Howard Regional Health System would like to amend its Byproduct Materials License, Number 13-13028-02, to list Richard Stephens, M.D. as the Radiation Safety Officer. Dr. Stephens has previously served as the Radiation Safety Officer on the Blackford Community Hospital U.S.N.R.C. license, Number 13-20449-01 (license terminated 2005). We ask that the currently listed R.S.O. on our license, Dr. Dada, be retained on the license as an Authorized User.

Finally, please find enclosed an updated facility diagram of the nuclear cardiology department. The updated diagram reflects the true direction of north, which was mislabeled on the facility diagram previously submitted.

CVL STRESS TESTING ROOM 1  
LOCATED IN THE BASEMENT IN THE  
CARDIOVASCULAR DEPARTMENT  
HOWARD REGIONAL HEALTH SYSTEM

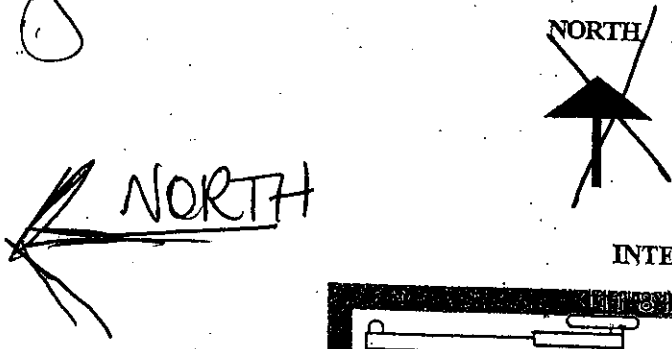
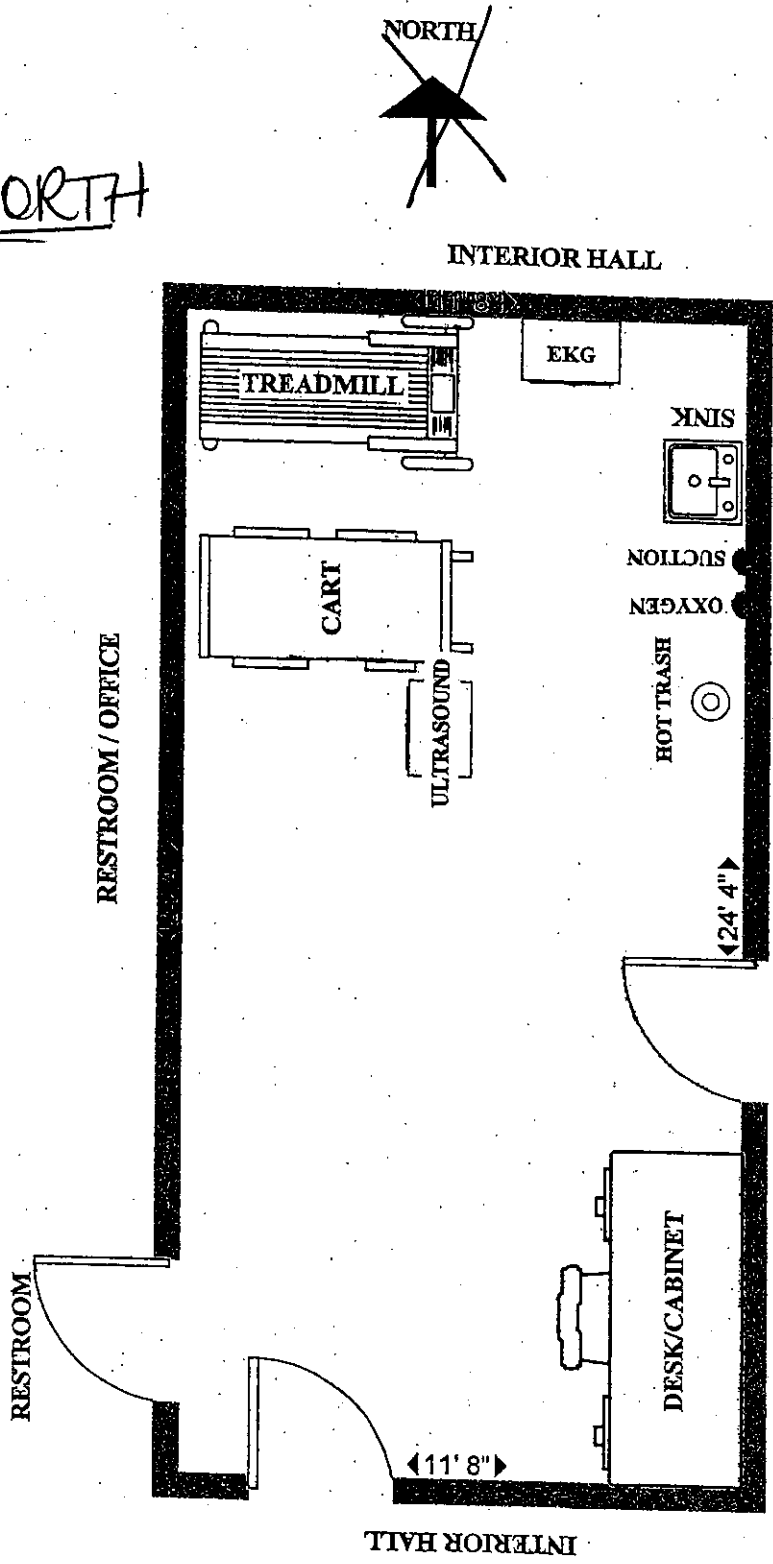
"North" direction corrected on 3/18/06 - will change on next amendment

CVL TESTING ROOM 7  
LOCATED IN THE BASEMENT IN THE  
CARDIOVASCULAR DEPARTMENT  
HOWARD REGIONAL HEALTH SYSTEM

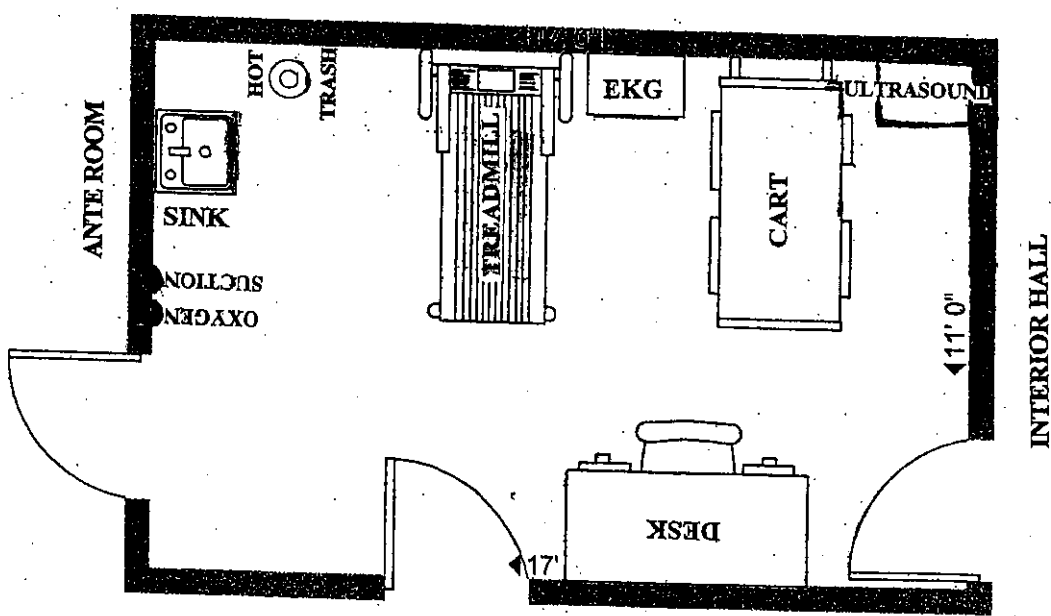
"North" direction corrected on 3/18/06 - will change on next amendment.
